NRC COMMENTS
ON
DOE DRAFT ENVIRONMENTAL ASSESSMENT
FOR THE
DAVIS CANYON SITE

March 20, 1985

NRC FIGURE 3-A AFTER DOE FIGURE 3-40

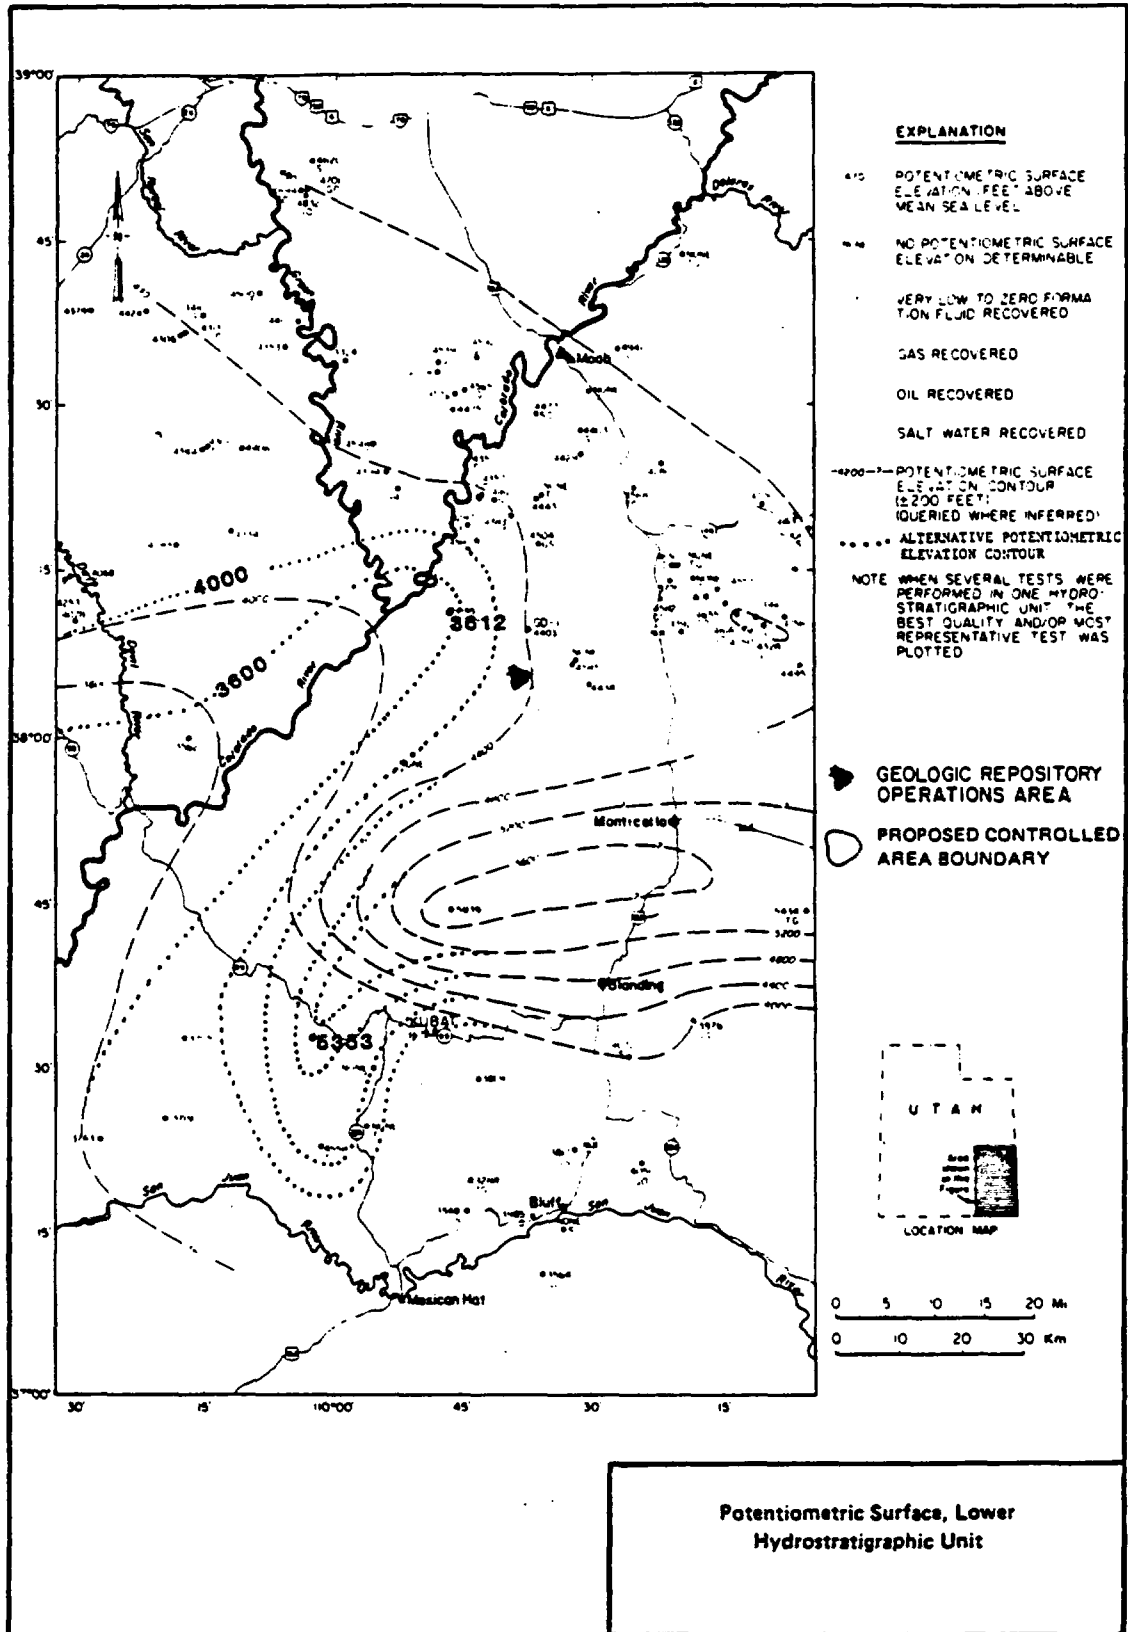
DOE presents a map (Figure 3-40) of the potentiometric surface of the lower hydrostratigraphic unit which includes incorrect values and inconsistencies when compared with the referenced data source (Woodward-Clyde, 1982, Vol. V, Appendix A). A revised potentiometric map based upon consideration of the concerns discussed below would alter flow direction to a northwest direction.

Figure 3-40 may include an incorrect head value. A well located immediately west of borehole GD-1 is labeled with a head value of 4,195 feet on Figure 3-40, but is listed at 3,612 feet in Appendix A (Woodward-Clyde, 1982, Vol. V). A change of the plotted value to 3,612 feet alters the shape of the potentiometric surface significantly by creating a major reentrant for the 4,000 to 3,600 foot contour lines. Given a revised potentiometric map based on this change, the flow path direction under the Davis Canyon site changes to a strong northwest trend; flow goes more directly toward the Colorado River.

There are additional discrepancies between Figure 3-40 and Appendix A. Some wells plotted in Figure 3-40 are not listed at all in Appendix A. For example, a well located near the northwest corner of the map area, with a head value of 4,379 feet, is not listed in the appendix. Conversely, some wells listed in the appendix are not plotted on Figure 3-40 or its earlier versions. For example, a well listed in Section 27 of T.37 S., R.17 E., apparently has not been plotted in the figure. If this well is plotted and the correct value is plotted for the well near borehole GD-1, the shape of the potentiometric surface is altered significantly. In addition, many of the wells listed in Appendix A (Woodward-Clyde, 1982), have head values obtained from testing more than one interval. A note on Figure 3-40 indicates that a selection process was used to determine which one of the values was to be plotted; however, no discussion is presented in Woodward-Clyde (1982) or the draft EA to explain the basis of the selection process. Selection of values other than those used could also significantly alter the potentiometric surface map.

Replotting of Figure 3-40 after the alterations described above can produce an alternative potentiometric surface for the Leadville Formation. The configuration of the alternative potentiometric surface map is presented below (see Figure 3-A). This alternative potentiometric map indicates the Colorado River may be a much stronger hydraulic sink northwest of the geologic repository operations area than was the case for the original map. The gradient between the repository and the river is steepened.

Section 3.3.2.1, Hydrology and Modeling, Page 3-133 to Page 3-135, Table 3-12

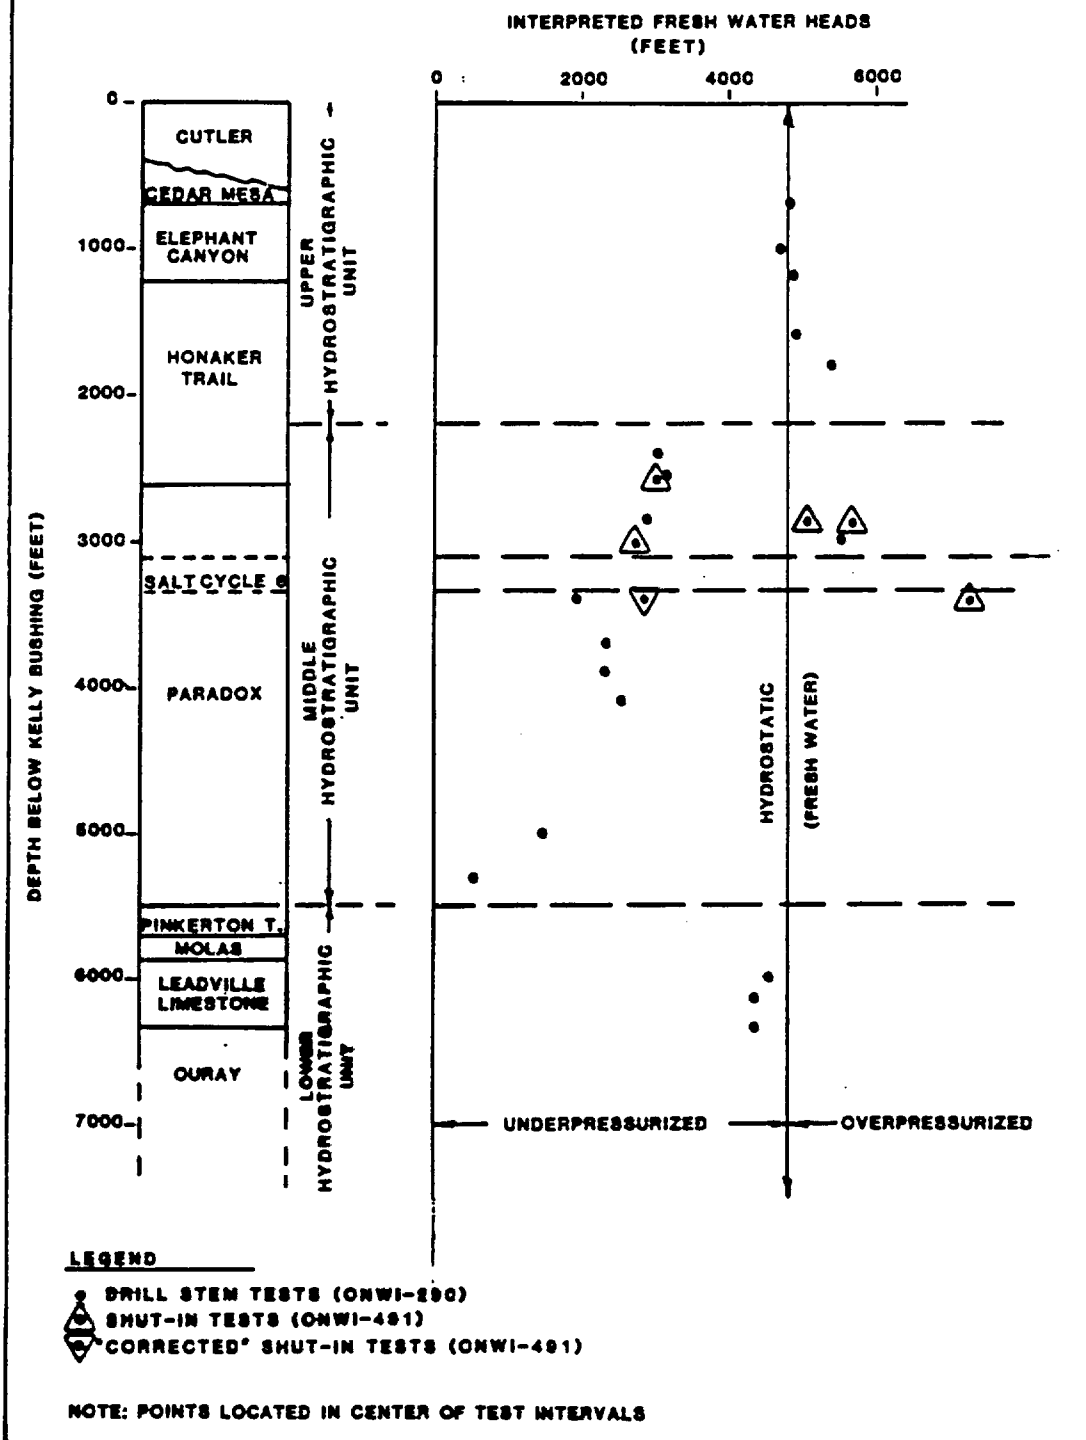
This Table does not show all potentiometric head data collected by DOE at borehole GD-1 which are used to support conclusions in the draft EA. If the potentiometric and estimated static reservoir data collected in the second series of tests (August-September, 1982) at borehole GD-1 were added to this table, complete consideration of the range of possible interpretations of gradient and flow direction for the middle hydrostratigraphic unit would be facilitated.

Head data from borehole GD-1 are variable. Figure 3-B (on previous page) depicts the short-term drill stem test head data (data points shown as circles) presented on Table 3-12 of the draft EA which were collected at borehole GD-1 from March 1980 to January 1981. The figure also shows the long-term shut-in test data (shown as triangles) collected at borehole GD-1 during August-September 1982 (Thackston, et al., 1984, Table 4-2). The Figure indicates that the potentiometric head profiles within each of the upper and lower hydrostratigraphic units each separately conform to a hydrostatic profile 0.4333 psi/ft (Thackston et al., 1984, p.11). In contrast, head within the Paradox Formation varies considerably with depth. The NRC concludes that consideration of the long-term test data increases the variability of measurements significantly. The long-term test data can be interpreted to indicate several alternative hydraulic conditions at borehole GD-1, including overpressurized and underpressurized conditions, as well as the possibility of localized upward and downward gradients. If there is localized vertical interconnection in these units, these head data suggest that there may be localized downward and upward flow. Hydrochemical data from borehole GD-1 may further substantiate the potential for localized upward gradients between the middle and upper hydrostratigraphic units (see detailed comment 3-29).
